REGULAR MEETING OF THE PLANNING COMMISSION

Monday, July 01, 2024

TOPIC Site Plan Discussion: VLO-24-02 (44 E. Flint) Mixed-Use Development

Subject: VLO-24-02 44 E. Flint, Site Plan Review #1

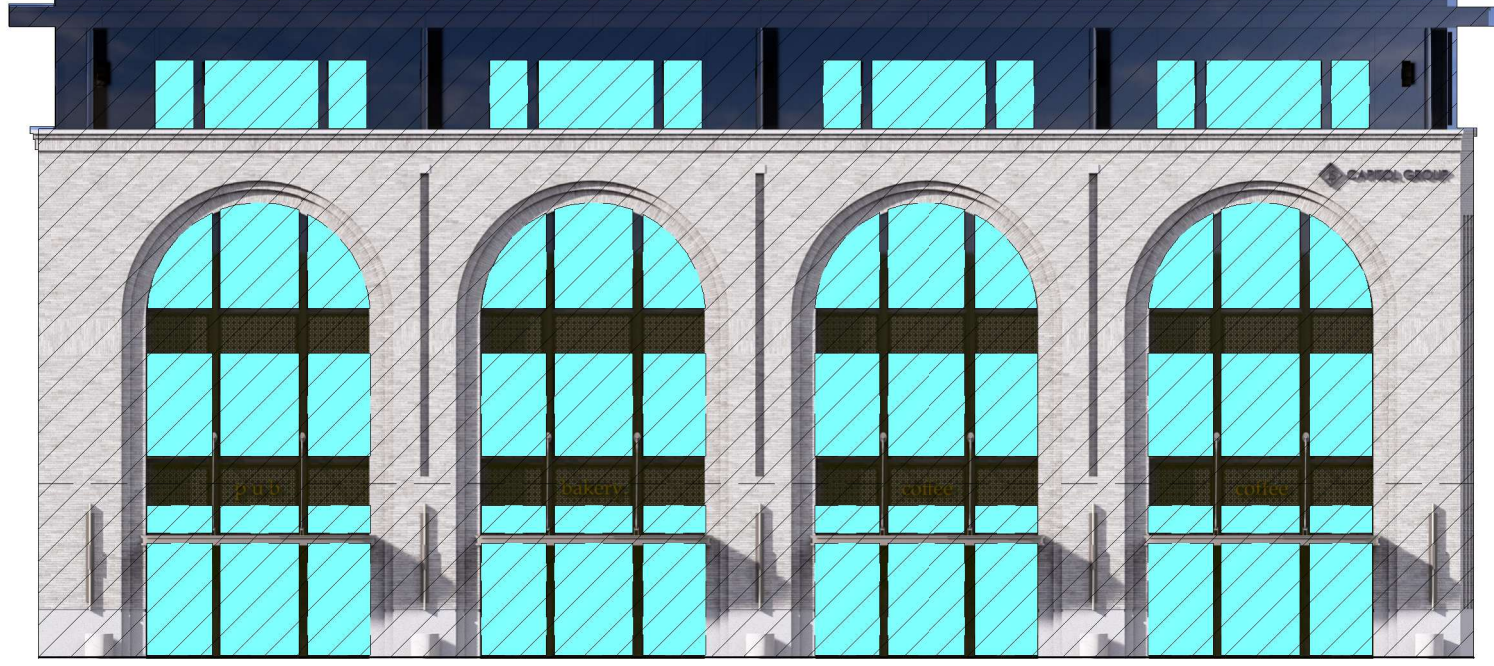
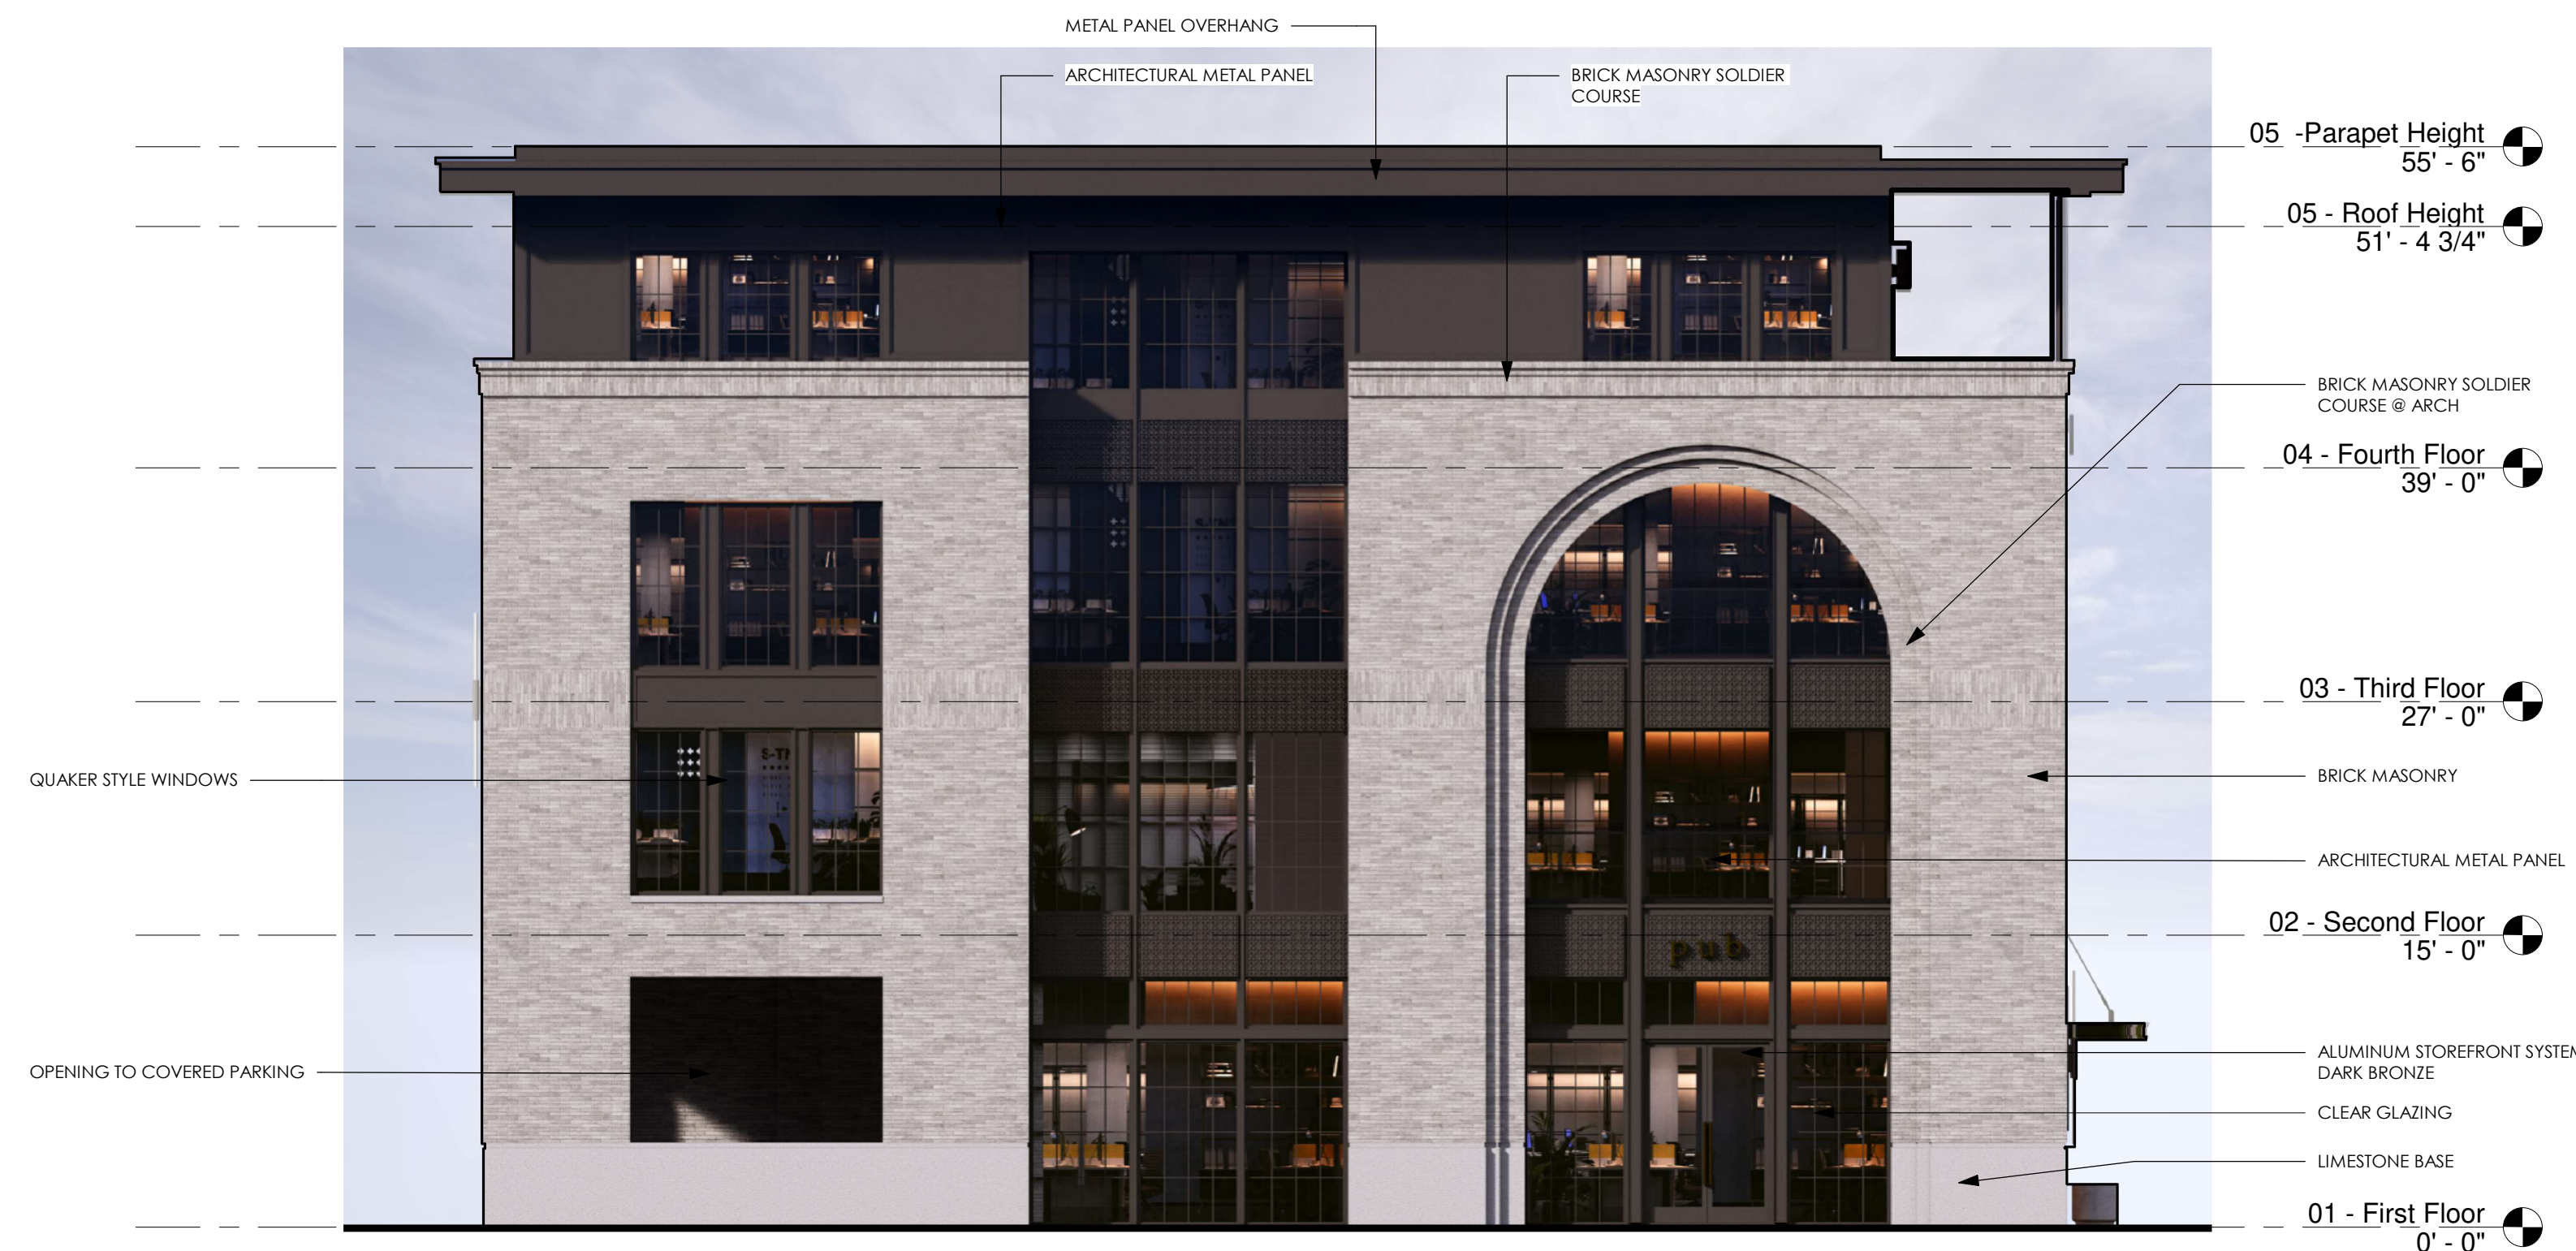
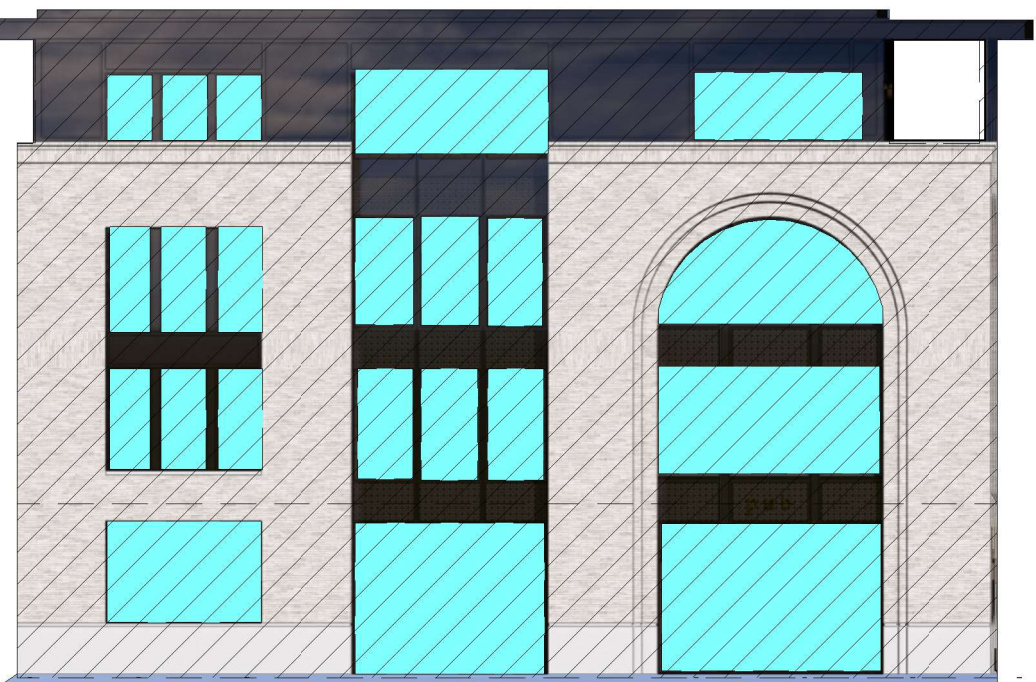
- d. *Shall have a discernible base and cap that are clearly defined by horizontal elements along the bottom and top of the building.* The proposal includes a clearly discernible cap, with charcoal-colored metal panels and heavy roof line. The ~4-ft.-high limestone base is not clearly discernible from the rest of the façade, being short relative to the height of the building and similarly lightly colored. We recommend a warmer, naturally colored primary masonry brick for the building to provide additional contrast with the limestone base and dark metal cap and to create a clearly defined horizontal base. This would also serve to soften the building's appearance and enhance compatibility with the surrounding area and historic feel without compromising the contemporary design.

- c. **Canopies.** Cloth fabric canopies are encouraged, while metal canopies are discouraged. This is not prescriptive language, and we believe the proposed metal canopies are satisfactory for the building. These shall provide 7.5-ft. clearance from the sidewalk.
